## **Landscape Referral Response**

Application Number:	DA2023/1109
Date:	24/08/2023
Proposed Development:	Subdivision of one lot into three and alterations and additions to the existing development
Responsible Officer:	Jordan Howard
Land to be developed (Address):	Lot 17 DP 23118 , 39 Starkey Street FORESTVILLE NSW 2087

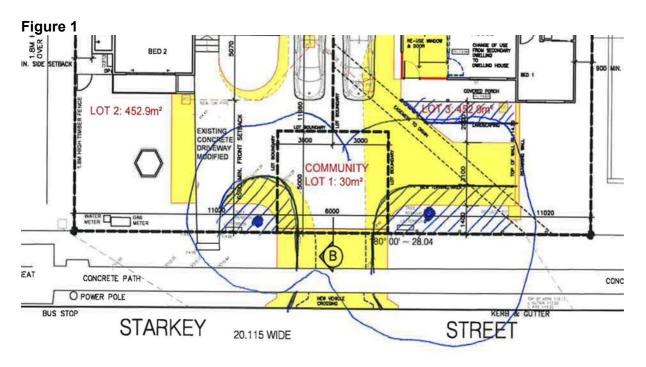
The proposed development layout within the frontage includes extensive hardstand areas that if approved does not allow adequate areas for replacement tree planting to provide the necessary landscape outcome to satisfy WDCP control D1 Landscaped Open Space and Bushland Setting, where the requirements are to: enable planting to maintain and enhance the streetscape; and provide for landscaped open space with dimensions that are sufficient to enable the establishment of low lying shrubs, medium high shrubs and canopy trees of a size and density to mitigate the height, bulk and scale of the building.

It is Landscape Referral's assessment that the proposed layout impacts upon the viability for retention of existing trees of amenity value and worthy of retention, and amendments should be attended to providing a design layout solution that is able to satisfy the requirements of the WDCP, including:

- realignment of turning area away from T1 Bottlebrush and reduction of widened driveway (refer Figure 1 below),
- retention of existing hardstand around T2 Sasanqua and reduction of widened driveway (refer Figure 2 below).
